REMARKS

Claims 1-30 were pending in the above-identified application and stand rejected.  
Applicants respectfully request reconsideration.

RB1-030USC2  
(RA226.D1C1.US)

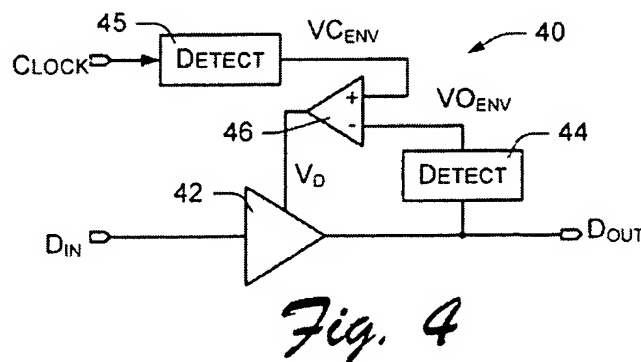
In claims 1, 9, 15 and 22, the limitations “signal envelope voltage”, “clock envelope voltage” and “group envelope voltage” are recited. However, the specification does not explain the natures of the signal envelope voltage, clock envelope voltage and group envelope voltage. Without some disclosure as to what constitutes the signal envelope voltage, clock envelope voltage and group envelope voltage, *one skilled in the art not [sic] be able to make and use the signal envelope voltage, clock envelope voltage and group envelope voltage.*

Applicants' specification introduces a "signal envelope voltage" in connection with Fig.

The automatic gain control is implemented in part by signal envelope detection circuitry 44 that is responsive to the amplified data output signal  $D_{OUT}$  to indicate an amplified **signal envelope voltage**  $VO_{ENV}$ .  $VO_{ENV}$  tracks the voltage swing or peak voltage of  $D_{OUT}$ .

(Spec., page 8, lines 2-5, emphasis added.) The emphasized language refers to the signal envelope voltage, which is abbreviated  $VO_{ENV}$  in Fig. 4 and elsewhere. Fig. 4, reproduced below, clearly shows the "signal envelope detection circuitry 44" of the quote, including the node that provides the "signal envelope voltage  $VO_{ENV}$ " in support of the identical claim language. Fig. 4, and the corresponding text, shows how to "use" a signal envelope voltage in accordance with one embodiment.

*Fig. 2*  
*Prior Art*

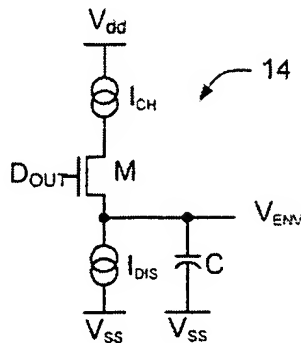
In the sentence immediately following the last quote, applicants' specification remarks that "Fig. 2 shows a simplified example of an appropriate envelope detector" (*Id.* at lines 5 and 6). That is

to say, detector 44 of Fig. 4 can be implemented using the circuit of Fig. 2, a conventional envelope detector. Fig. 2 is reproduced below.

Fig. 2 and the associated text show how to “make” a signal envelope voltage for use in some embodiments, including the embodiment of Fig. 4. Applicants’ specification thus fully describes and schematically details circuits for making (Fig. 2) and using (Fig. 4) a “signal envelope voltage” in support of the claims. This is ample direction for those familiar with gain control and signal receivers. The rejections of the claims for failing to enable a “signal envelope voltage” should therefore be withdrawn.

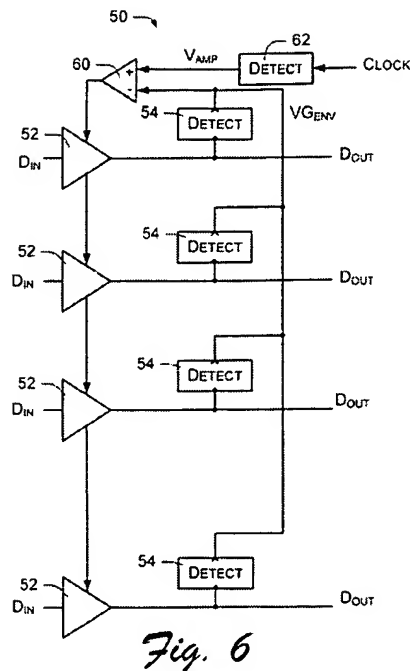
Applicants’ specification makes many references to a “group envelope voltage,” the first of which occurs on page 10 in connection with a discussion of Fig. 6.

Receiver 50 has **group envelope detection circuitry that is responsive to the collective amplified data signals Dour to indicate a group envelope voltage.** In this example, the group envelope detection circuitry comprises a plurality of individual envelope detectors 54 whose capacitive outputs are connected in common to form **a group envelope voltage signal  $V_{G_{ENV}}$** . In this configuration, the detection circuitry is responsive to peaks in any of data output signals DOUT, and  $V_{G_{ENV}}$  generally tracks the most extreme peaks occurring at any moment on any of the data output signals.

Fig. 6 and the related text detail how to “use” a group envelope voltage  $V_{G_{ENV}}$  to control the gain of a group of amplifiers 52. Fig. 6, reproduced below, shows the group of envelope detectors 54 that generate a group envelope voltage signal  $V_{GENV}$  to control the gain of a group of amplifiers 52 via a feedback component 60.

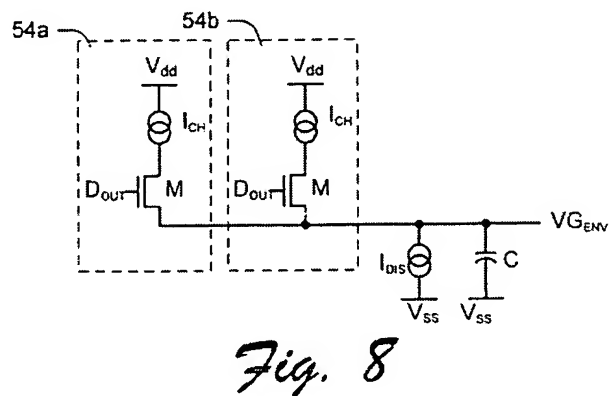
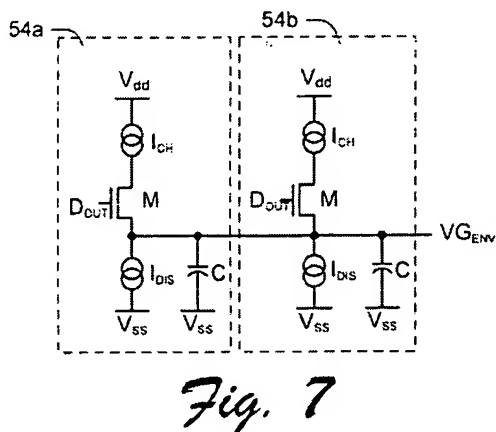
Figs. 7 and 8, reproduced below, show implementations of group envelope detection circuitry. Each circuit generates, or “makes,” a group envelope voltage  $V_{GENV}$  in support of the identical claim language.

The manner of making (e.g. Figs. 7 and 8) and using (e.g. Fig. 6) a “group envelope voltage  $V_{GENV}$ ” is thus fully described with reference to embodiments detailed in applicants’

Fig. 11

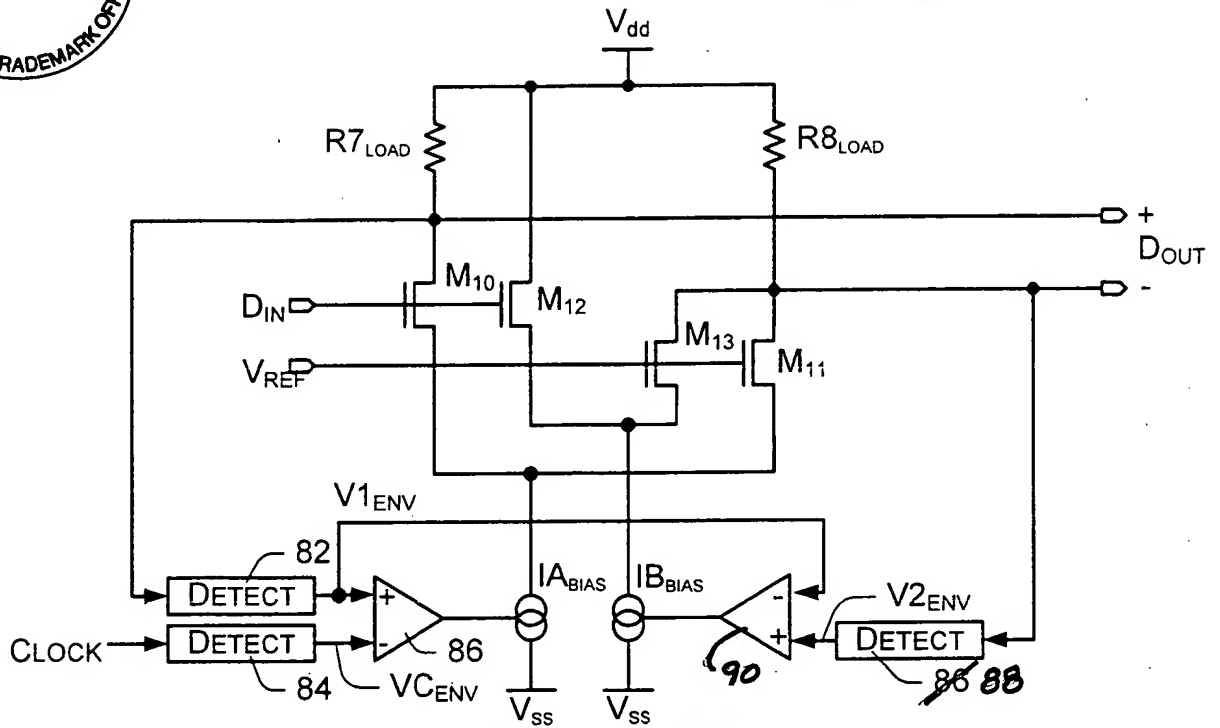
Please amend Figs. 11, 13, and 14 as indicated in red ink on the attached sheets. Applicants have also included corresponding substitute sheets, so labeled, for inclusion pending the examiner's approval of the changes. Applicants respectfully request upon approval of these replacement drawing sheets that the Examiner please forward them to the Office of Initial Patent Examination.
